AS-BUILT SANITARY DISPOSAL SYSTEM PLAN

#19 RYAN ROAD, LYNNFIELD

DRAWING: ASB

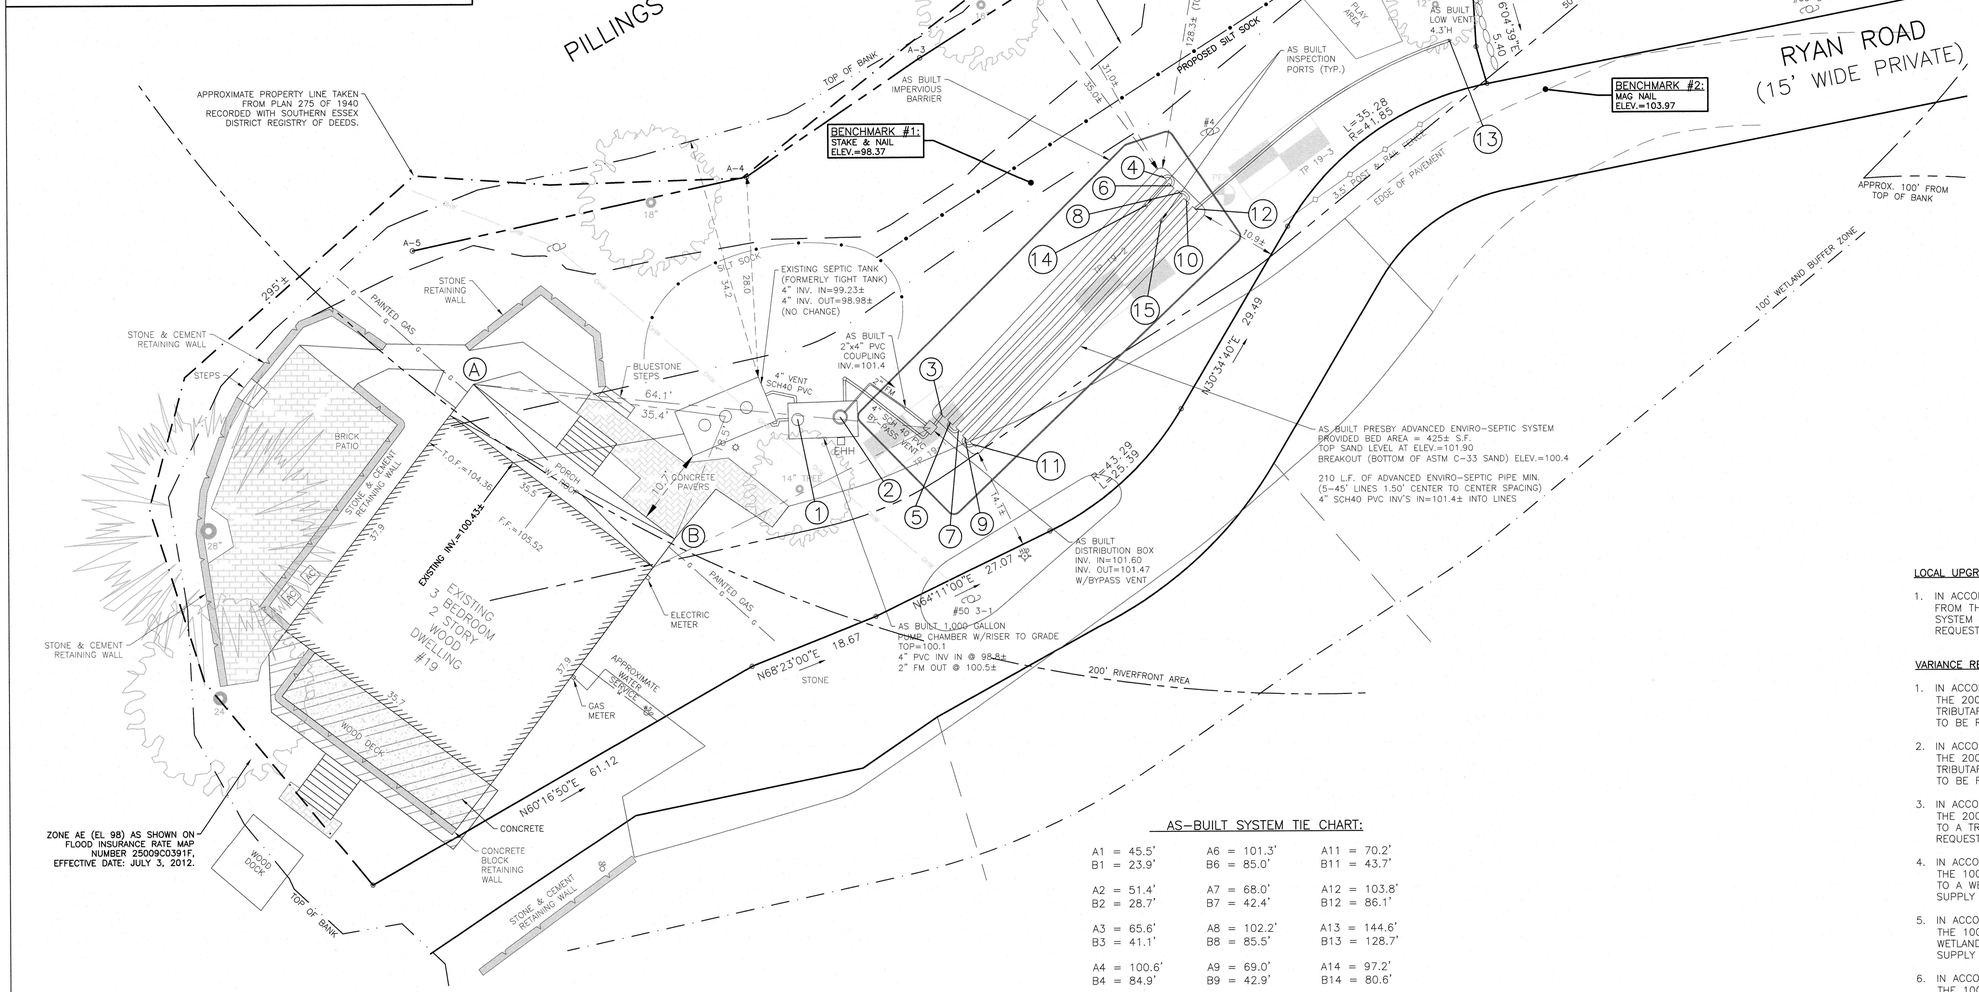
1) THE CONTRACTOR SUBSTITUTED A LIBERTY LE41 SUBMERSIBILE PUMP WITH EZ PULL IN PLACE OF THE BARNES SE411 SHOWN ON THE APPROVED DESIGN. IT IS OUR UNDERSTANDING THAT THIS CHANGE WAS WITNESSED AND APPROVED IN THE FIELD BY THE LYNNFIELD BOARD OF HEALTH REPRESENTATIVE, LEO CORMIER.

2) THE CONTRACTOR RELOCATED THE ELECTRICAL OUT OF THE PUMP CHAMBER TO THE ELECTRIC HAND HOLD SHOWN, INCREASED THE SIZE OF THE FORCE MAIN FROM A 1 ¼" DIAMETER TO A 2" DIAMETER AND THROTTLED THE FLOW DOWN WITH A 2" BALL VALVE. IT IS OUR UNDERSTANDING THAT THIS CHANGE WAS WITNESSED AND APPROVED IN THE FIELD BY THE LYNNFIELD BOARD OF HEALTH REPRESENTATIVE, LEO CORMIER.

3) THE CONTRACTOR INSTALLED AN ADDITIONAL VENT PIPE FROM THE PUMP CHAMBER TO THE SEPTIC TANK IN ORDER TO PROVIDE ADDITONAL AIR FLOW FOR THE ZABEL EFFLUENT FILTER. IT IS OUR UNDERSTANDING THAT THIS CHANGE WAS WITNESSED AND APPROVED IN THE FIELD BY THE LYNNFIELD BOARD OF HEALTH REPRESENTATIVE, LEO CORMIER.

4) THE PUMP CHAMBER WAS RELOCATED IN ORDER TO AVOID THE EXISTING 14" TREE SHOWN ON THE PLAN.

5) WILLIAMS & SPARAGES WAS NOT NOTIFIED OF THESE CHANGES AND IT SHOULD BE NOTED THAT WE ASSUME NO RESPONSIBILITY FOR THE PERFORMANCE OF THESE MODIFICATIONS.
